**Application of Scope Builders, LLC c/o Battle Law, P.C. for a Special Land Use Permit (SLUP) to allow a drive-through facility for a pharmacy (in conjunction with a convenience store and retail) in an activity center (Town Center) character area in the C-1 (Local Commercial) zoning district, at 3820 and 3828 North Decatur Road.**

**PETITION NO: N5-2026-0142 SLUP-26-1247928**

**STAFF ANALYSIS**

### Zoning Comments March 2026

**CONCEPT ZONING PLAN  
FOR  
NORTH DECATUR RETAIL**  
3820 NORTH DECATUR ROAD  
LAND LOT 12, 18TH DISTRICT, TAX ID: 18 012 10 004  
DEKALB COUNTY, GA

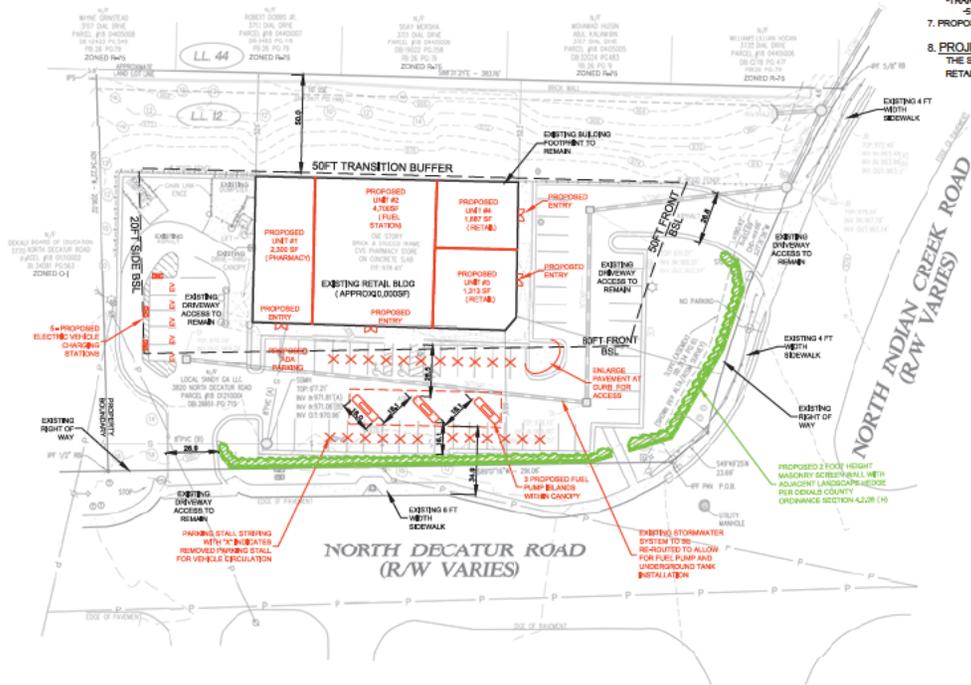
properties zoned R-75 to the north. The existing drive-through may be partially nonconforming with respect to Section 27-4.2.23. and Section 27-6.1.3. (specifically with respect to maneuverability). The proposed conversion of the main structure into a shopping center would require at least one (1) loading space, which must be screened from view of any ROW, per Section 27-6.1.14. of the *Zoning Ordinance*. This does not appear to be taken into consideration on the site plan, and the lack of a loading space would require a variance from the Zoning Board of Appeals (ZBA) or a change to the site plan (which would likely be in the area of the drive-through). An existing dumpster is located near the lanes of the existing/proposed drive-through, which may not be sufficient for Sanitation (Section 27-7.4.6. (I)). While Staff typically favors “adaptive re-use” of existing buildings and sites, the decision to utilize the existing building footprint may impede a more flexible and pedestrian-oriented design that could visibly enhance the corridor while also complying with modern Code requirements. Staff has previously supported some drive-through facilities in activity centers when said facilities 1) have already existed on-site to some extent, and 2) when the development of the sites have led to substantial improvements in landscaping, streetscaping, and pedestrian accessibility, and 3) when the sites have been located at the edge of an activity center. Although small improvements are proposed to be made to the streetscape zones in County Right-of-Way (ROW) along the properties’ frontages on North Decatur Road and North Indian Creek Road, these proposals may not be adequate to advance the TC character area’s goals (particularly in light of possible adverse impacts on adjacent single-family subdivisions) and there are no substantial changes around the existing drive-through structure and lanes (Section 27-7.4.6. (H)). At the Community Council District 4 meeting held on February 17, 2026, there was significant opposition from the community members present as well as from members of Community Council, who echoed the above concerns and voted unanimously to recommend Denial of the application request (Section 27-7.4.6. (N)). Therefore, upon review of the criteria set forth in Section 27-7.4.6. of the Zoning Ordinance, the Planning and Sustainability Department recommends “**Denial**” of the subject request for a Special Land Use Permit (SLUP).

The properties are physically restricted by their lack of relative depth and the requirement for a 50-foot transitional buffer adjacent to the residential properties zoned R-75 to the north. The existing drive-through may be partially nonconforming with respect to Section 27-4.2.23. and Section 27-6.1.3. (specifically with respect to maneuverability). The proposed conversion of the main structure into a shopping center would require at least one (1) loading space, which must be screened from view of any ROW, per Section 27-6.1.14. of the *Zoning Ordinance*. This does not appear to be taken into consideration on the site plan, and the lack of a loading space would require a variance from the Zoning Board of Appeals (ZBA) or a change to the site plan (which would likely be in the area of the drive-through). An existing dumpster is located near the lanes of the existing/proposed drive-through, which may not be sufficient for Sanitation (Section 27-7.4.6. (I)).

While Staff typically favors “adaptive re-use” of existing buildings and sites, the decision to utilize the existing building footprint may impede a more flexible and pedestrian-oriented design that could visibly enhance the corridor while also complying with modern Code requirements. Staff has previously supported some drive-through facilities in activity centers when said facilities 1) have already existed on-site to some extent, and 2) when the development of the sites have led to substantial improvements in landscaping, streetscaping, and pedestrian accessibility, and 3) when the sites have been located at the edge of an activity center. Although small improvements are proposed to be made to the streetscape zones in County Right-of-Way (ROW) along the properties’ frontages on North Decatur Road and North Indian Creek Road, these proposals may not be adequate to advance the TC character area’s goals (particularly in light of possible adverse impacts on adjacent single-family subdivisions) and there are no substantial changes around the existing drive-through structure and lanes (Section 27-7.4.6. (H)).
